SITE MANAGEMENT TEAM MONTHLY CALL SUMMARY
FORMER DEFENSE DEPOT MEMPHIS, TENNESSEE
14 JUNE 2022
11:00 EDT

Offsite Groundwater Investigation

Figure 8

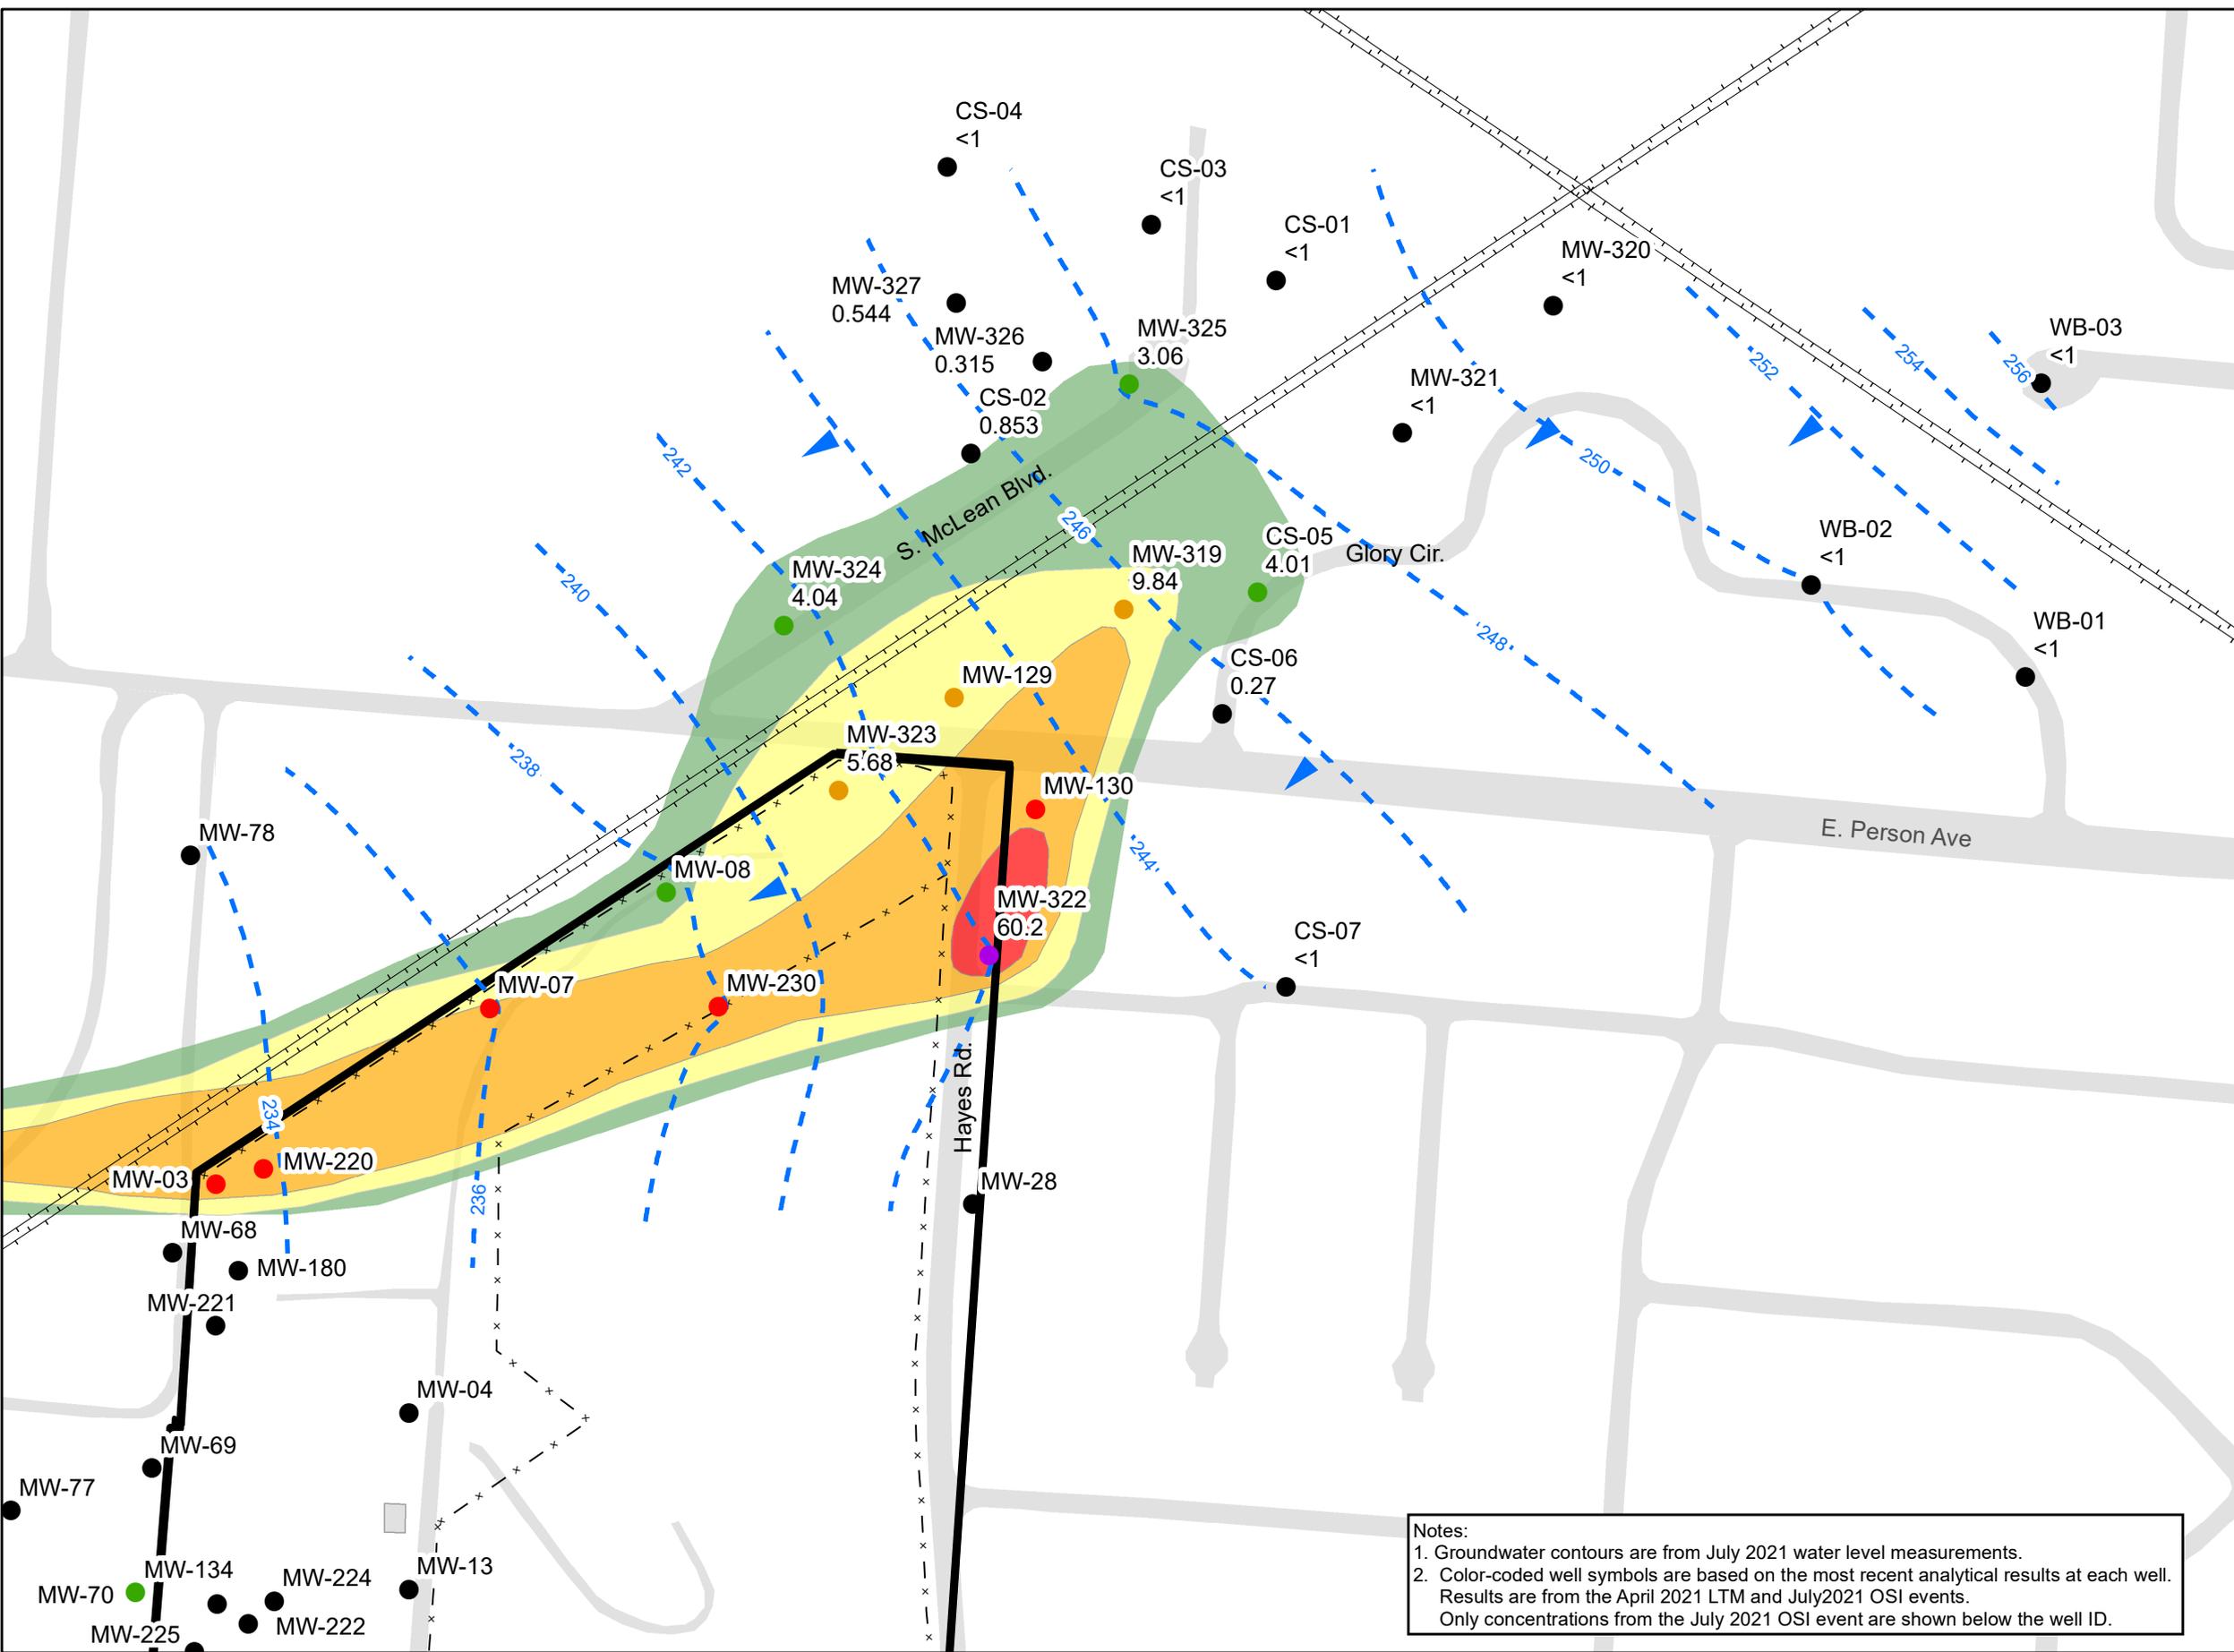
Mr. Holmes showed figures of trichloroethene (TCE) and 1,1-dichloroethene (DCE) concentrations from the OSI report; TCE is present upgradient (north) of Dunn Field and DCE to the northwest near the former Cintas facility. Mr. Martinez Torres asked if the plume is completely delineated. Mr. Holmes responded that the plume is delineated and indicated the number of wells on the figure with concentrations below the EPA maximum contaminant level

Figure 10
Intermediate Aquifer
Groundwater Elevations -
October 2021

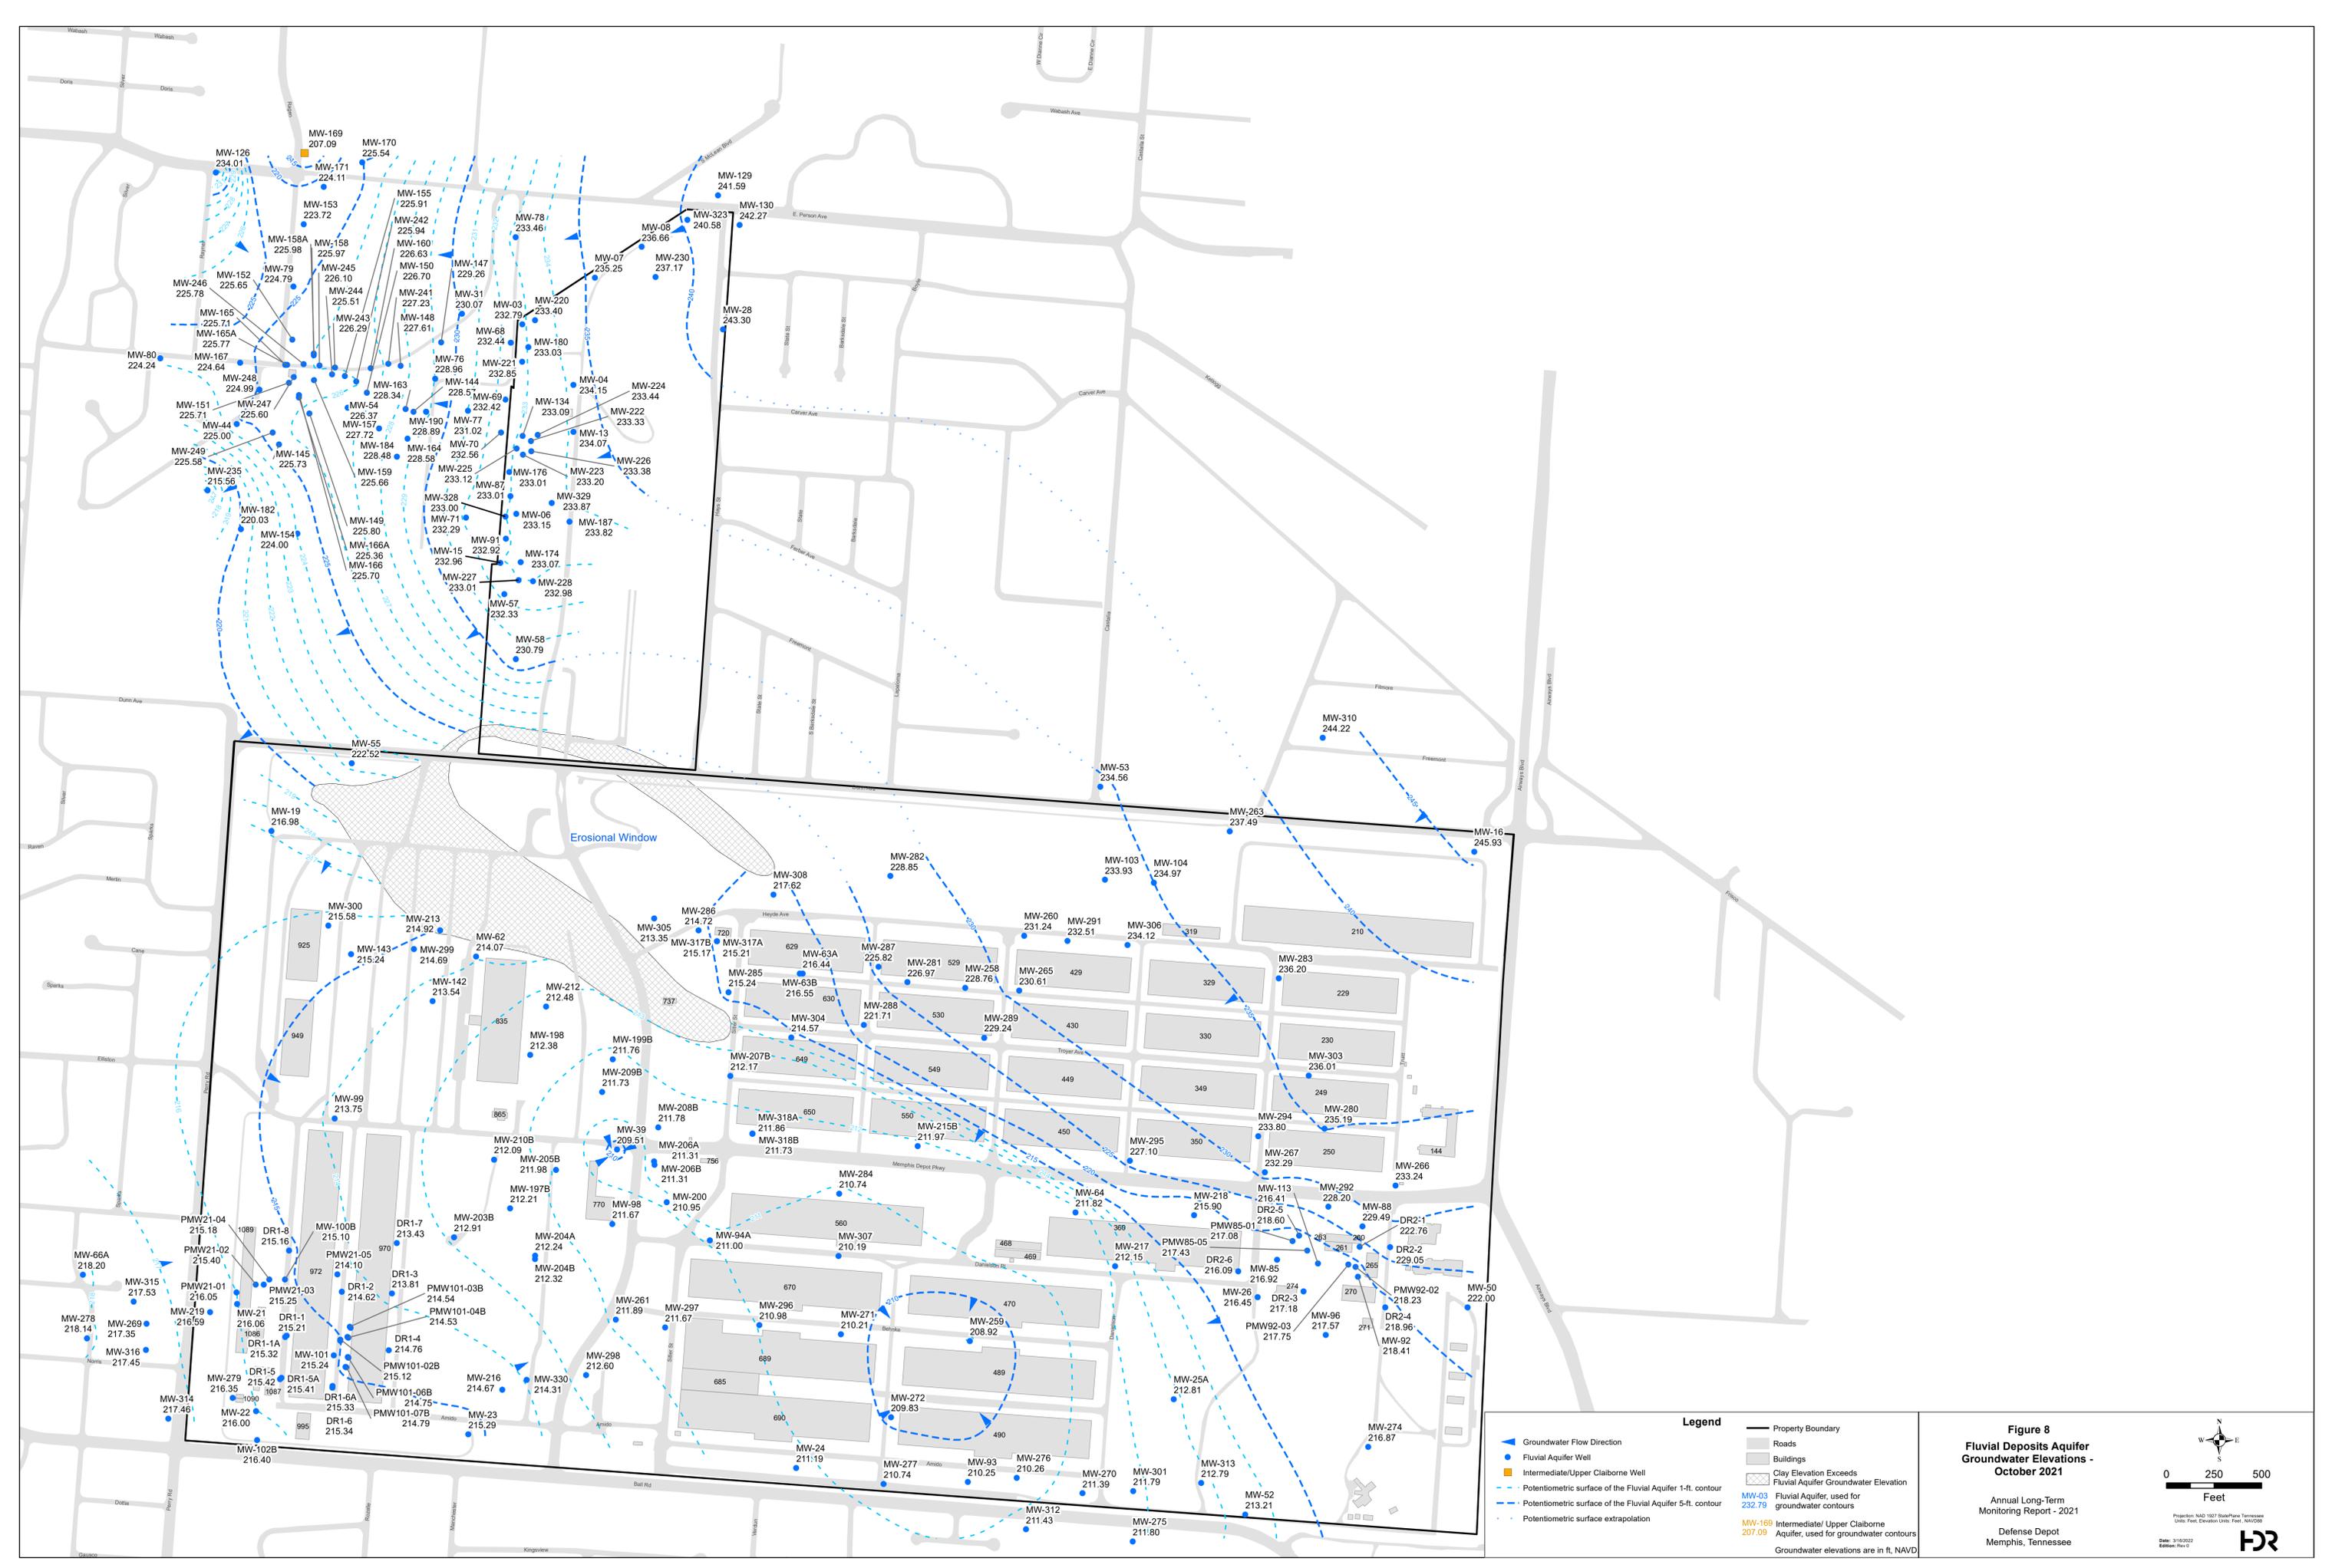
Mr. Holmes said that a second comment was whether contaminated groundwater may be drawn into the Memphis Aquifer within the drawdown area of Allen Well Field, which is located 1-2 miles west of Dunn Field. He stated vertical migration of groundwater contaminants would be indicated by groundwater flow contours and shared the October 2021 DDMT groundwater contour map for the Fluvial Deposits Aquifer (FDAQ). The groundwater flow direction for the Offsite plume on Dunn Field is west-southwest to a trough in the groundwater surface (225 feet elevation) about 1,000 feet west of Dunn Field, at which point groundwater flows to the north. There are no closed contours in the area of the plume indicating vertical leakage. He noted that the Intermediate Aquifer (IAQ) groundwater elevation at the trough is at 176 feet, approximately 50 feet lower than the Fluvial Deposits Aquifer.
